NAVIGATION - STALL WARNING HORN REPLACEMENT

MODEL	SERIAL NUMBERS
310Q/T310Q	310Q0460 thru 310Q1160
310R/T310R	310R0001 thru 310R2140

The original stall warning horn is no longer available. If the stall warning horn needs to be replaced, a new stall warning horn is available and will require an additional bracket for installation.

MEB-34-05
Page 1 of 23

Figure 8. 310Q Configuration 3 (Sheet 2)

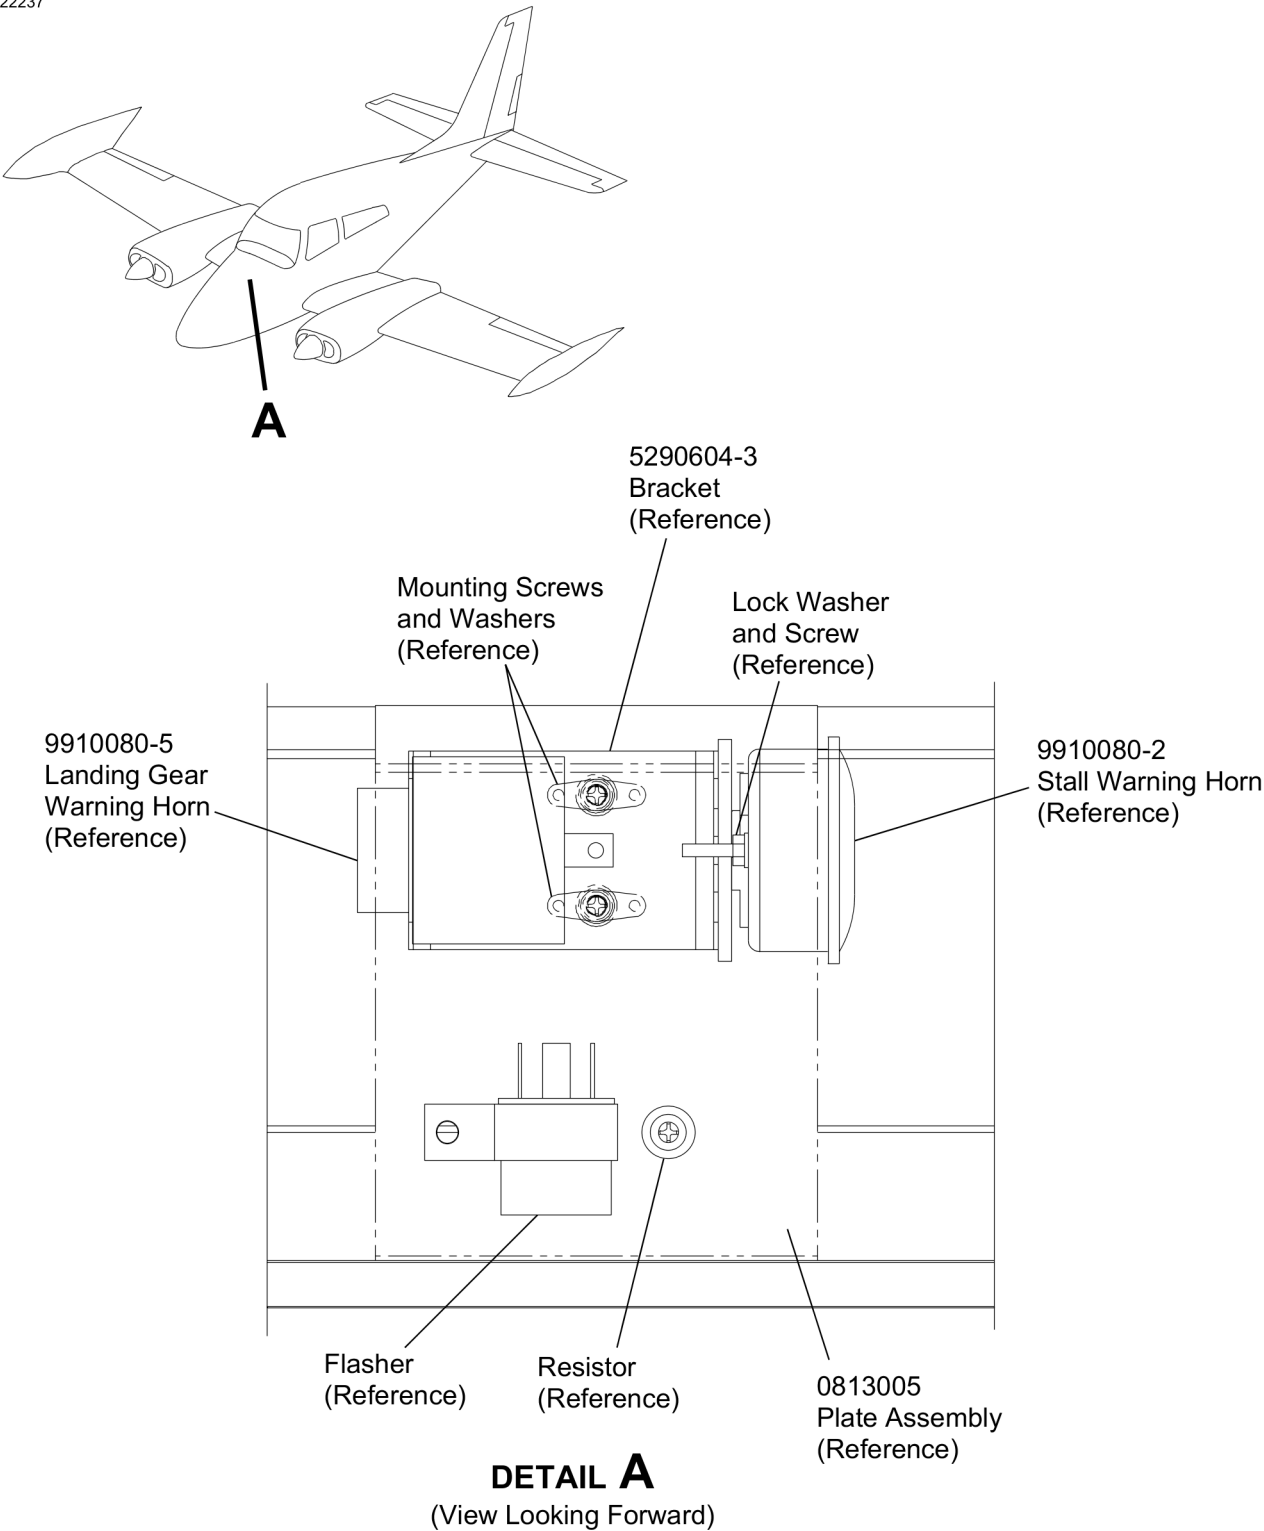
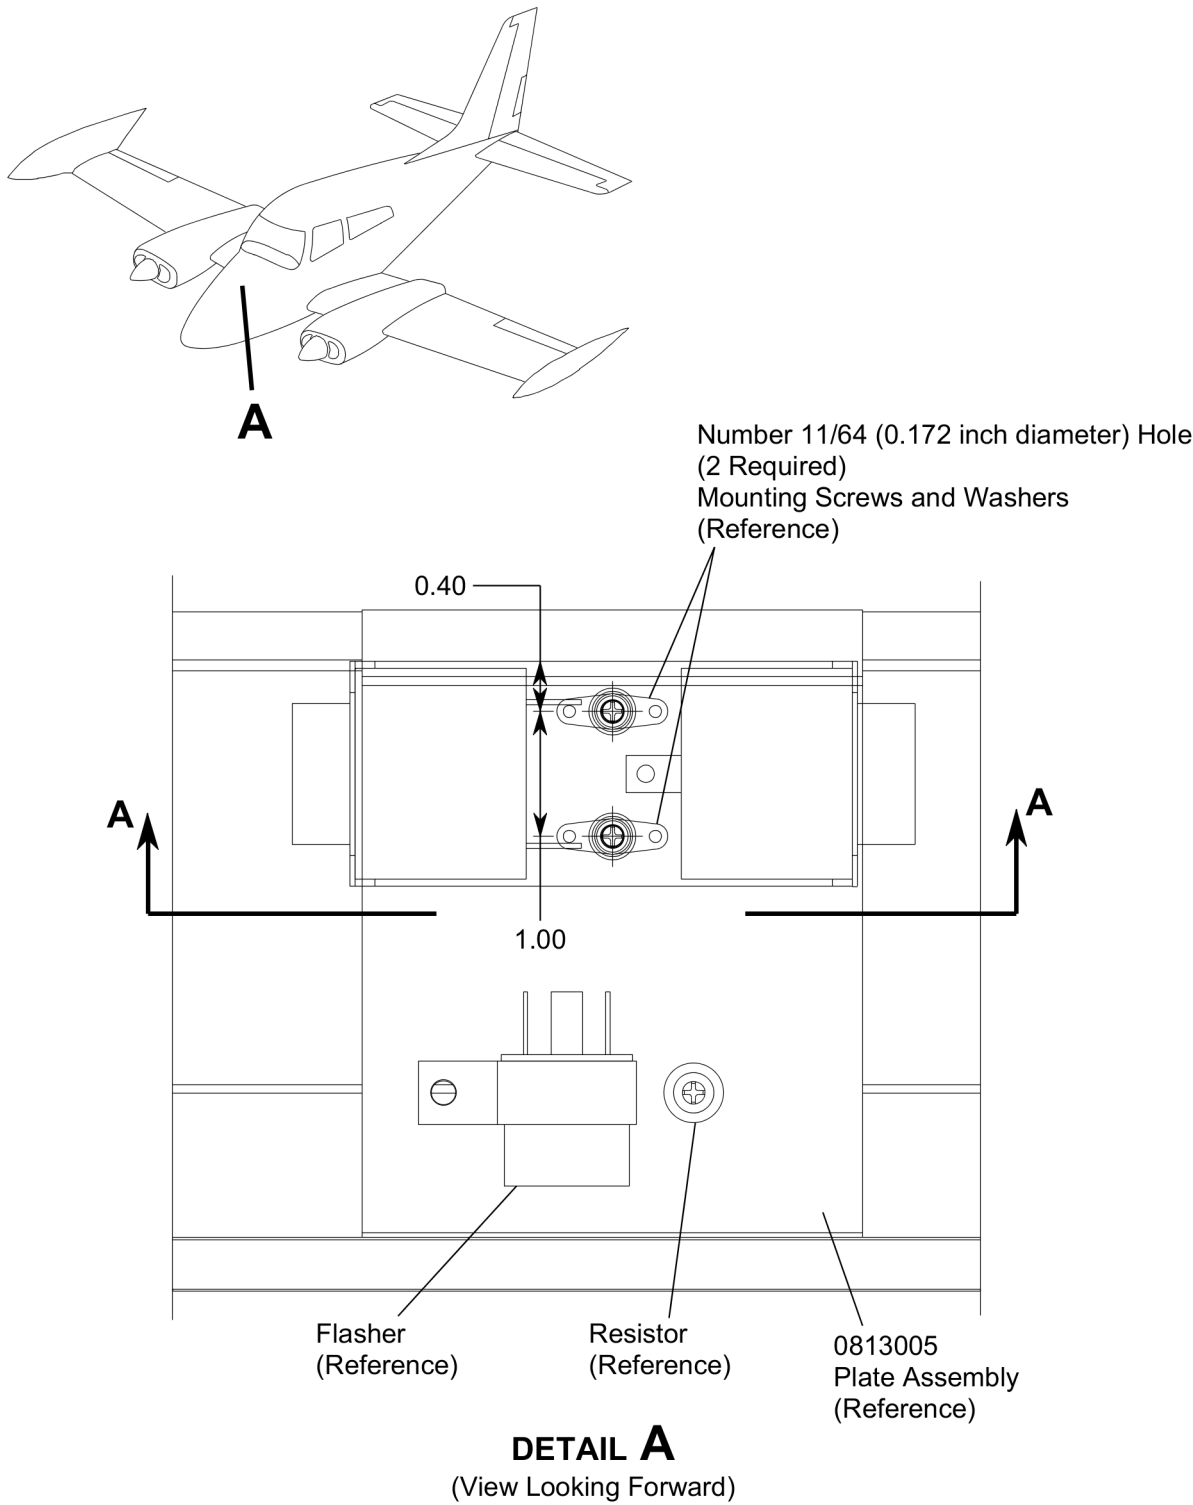
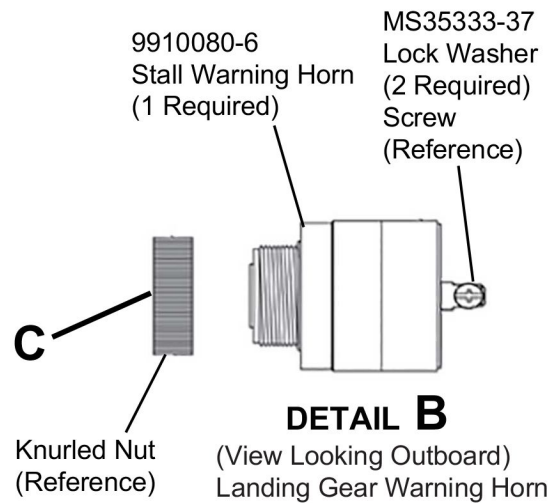
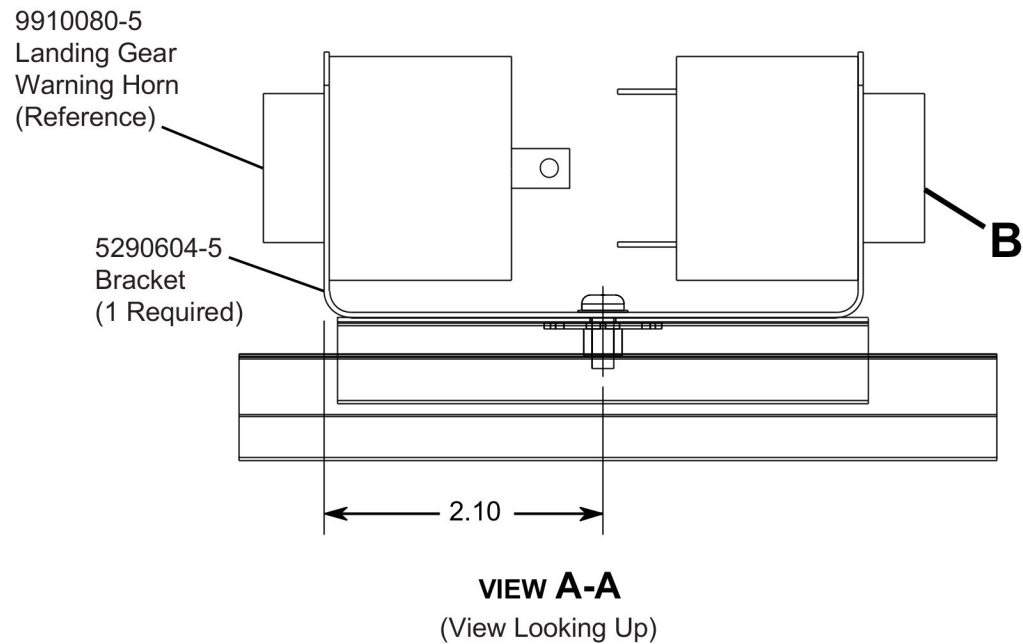
- 13. (For Model 310Q Refer to Figure 7, Sheet 1, and for Model 310R Figure 9, Sheet 1.) Remove the 9910080-2 Stall Warning Horn as follows:
 - A. Remove and discard the washer and lock screw from the 9910080-2 Stall Warning Horn.
 - B. Disconnect and label the electrical wiring from the 9910080-2 Stall Warning Horn.
 - C. Discard all electrical hardware from the 9910080-2 Stall Warning Horn.
 - D. Discard the 9910080-2 Stall Warning Horn.
 - E. Remove and keep the 9910080-5 Landing Gear Warning Horn.

- G. Discard the 5290604-3 Bracket.
- 14. (For Model 310Q Refer to Figure 8, Sheet 1 and 2, and for Model 310R Figure 10, Sheet 1 and 2.) Install the 9910080-6 Stall Warning Horn as follows:
 - A. (For 310Q airplanes.) Match drill the two Number 11/64 (0.172 inch diameter) holes of the 0813005 Plate Assembly to the 5290604-5 Bracket.
 - (1) Debur the drilled holes from the 5290604-5 Bracket.

C. Install the 5290604-5 Bracket with the kept mounting screws and washers into the 0813005 Plate Assembly or the 0818109 Support Assembly.

D. Install the 9910080-6 Stall Warning Horn into the 5290604-5 Bracket.

NOTE: The plastic knurled nut must be installed with the three indents toward the bracket and horn assembly. On the internal circumference, the smooth side without threads is installed first, towards the bracket and horn. This technique of installation will make sure the nut fully seats against the bracket and not bottom-out on the threads. If not installed correctly the knurled nut will bottom-out on the threads and the horn assembly will not be fully tightened in the bracket.

Figure 10. 310R Configuration 3 (Sheet 2)

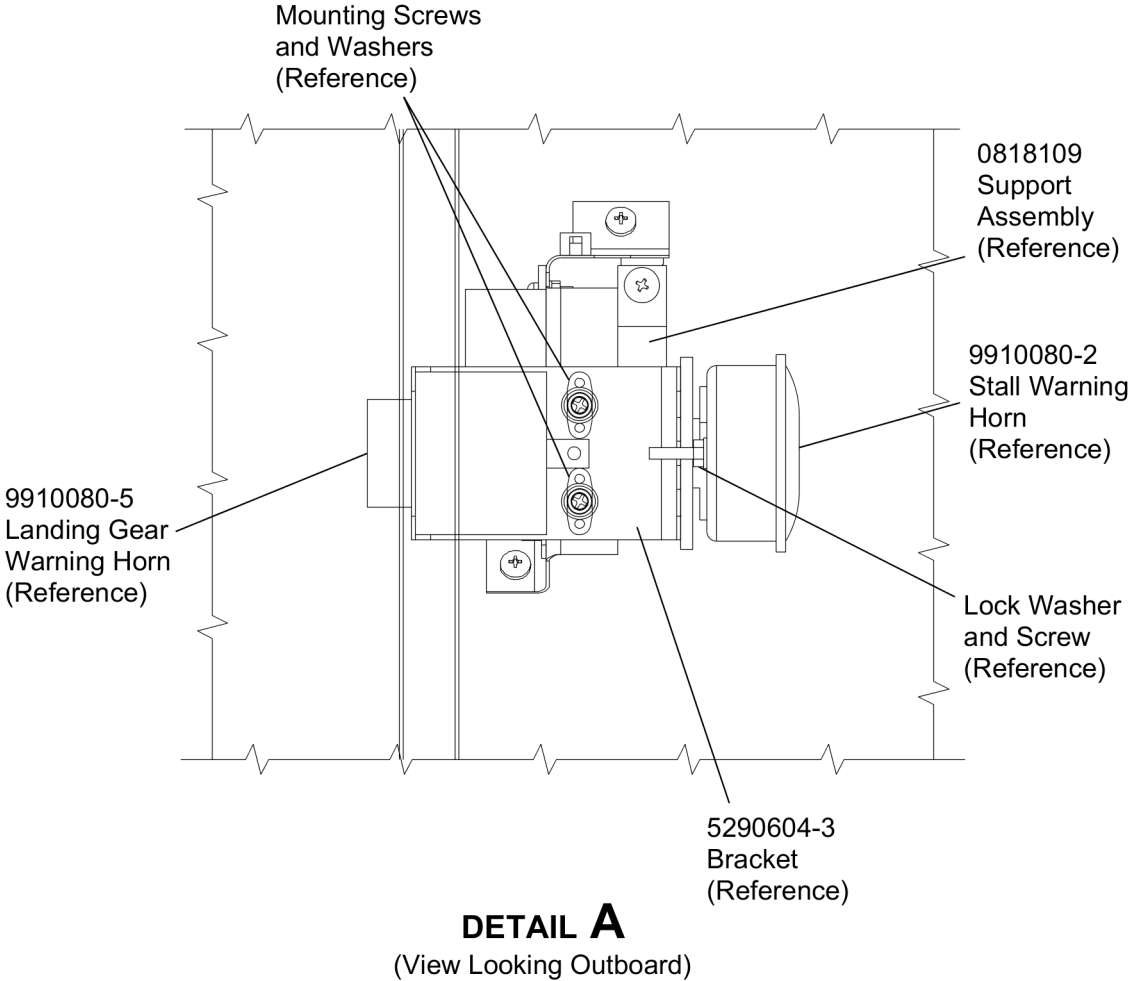
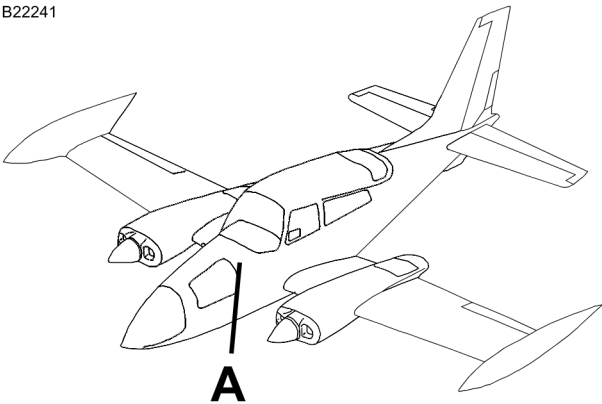
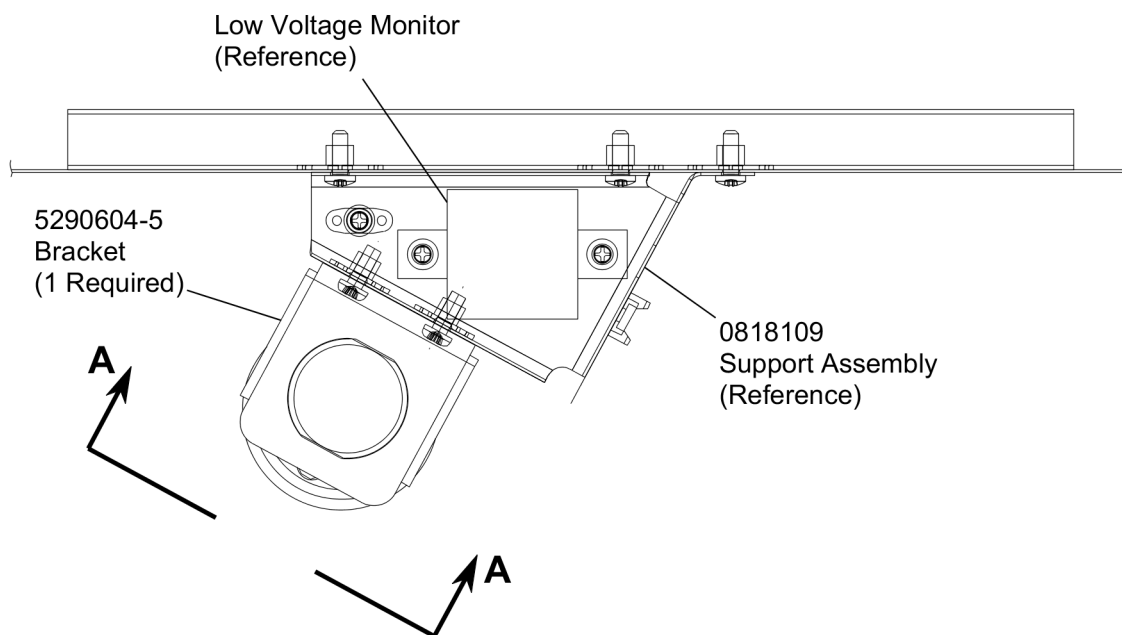
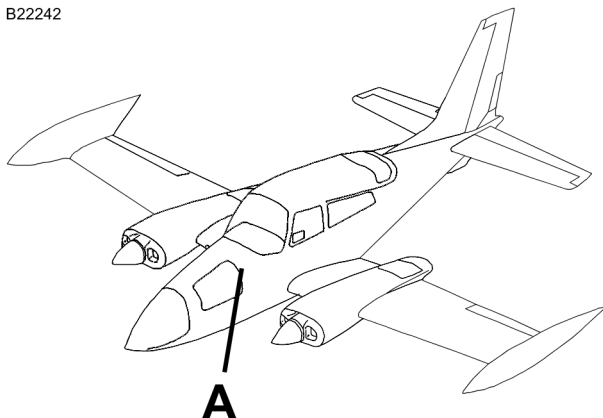
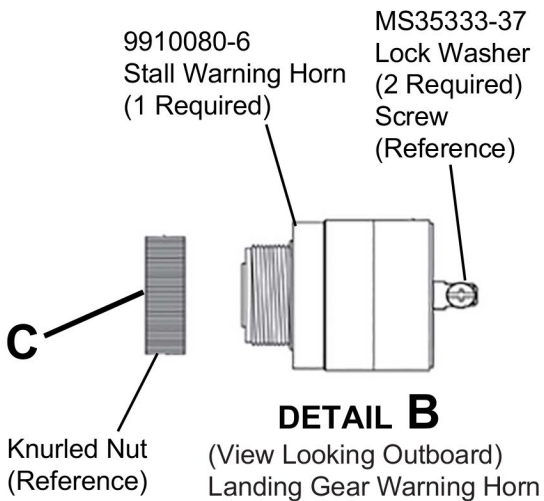
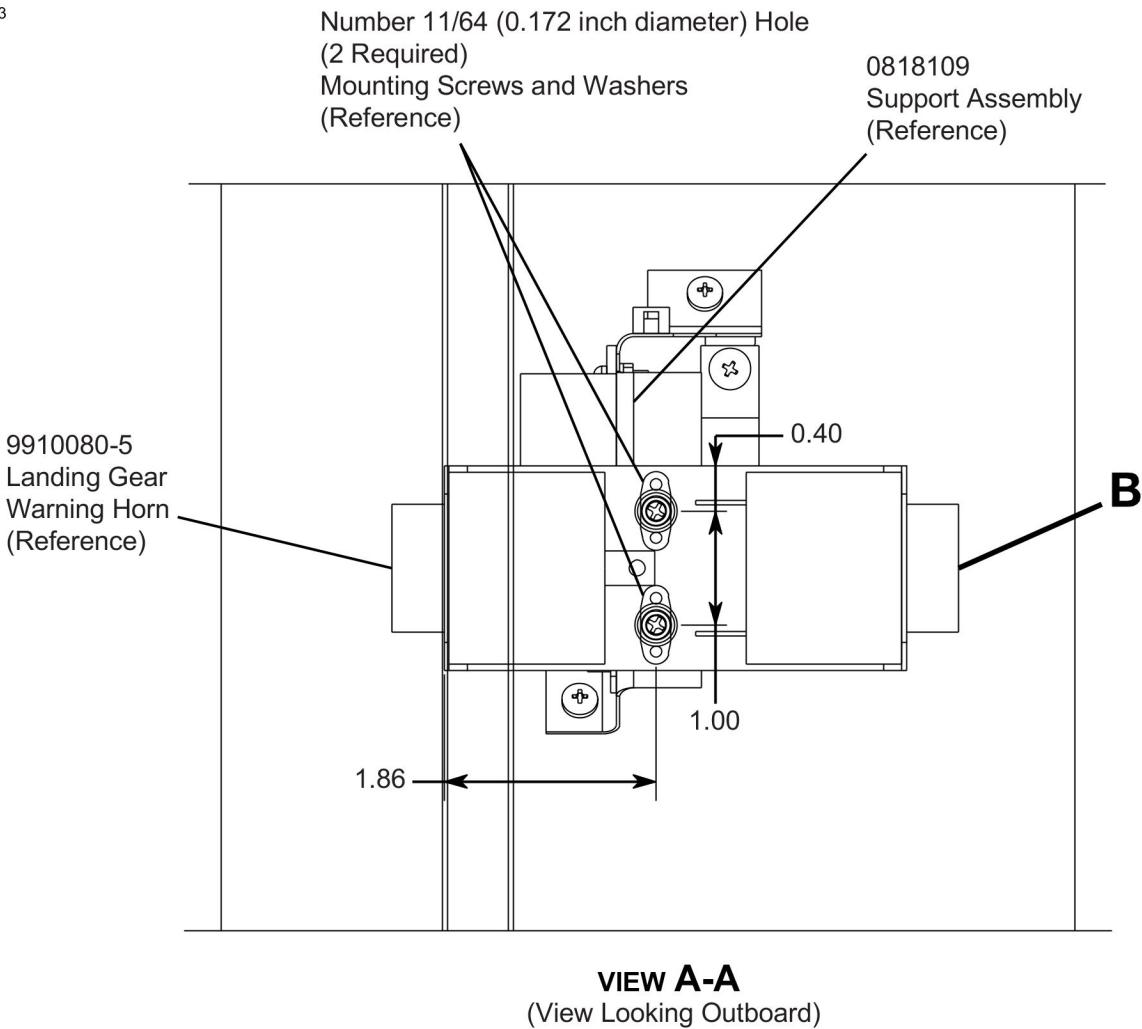
B. (For Model 310R airplanes.) Match drill the two Number 11/64 (0.172 inch diameter) holes of the 0818109 Support Assembly to the 5290604-5 Bracket.
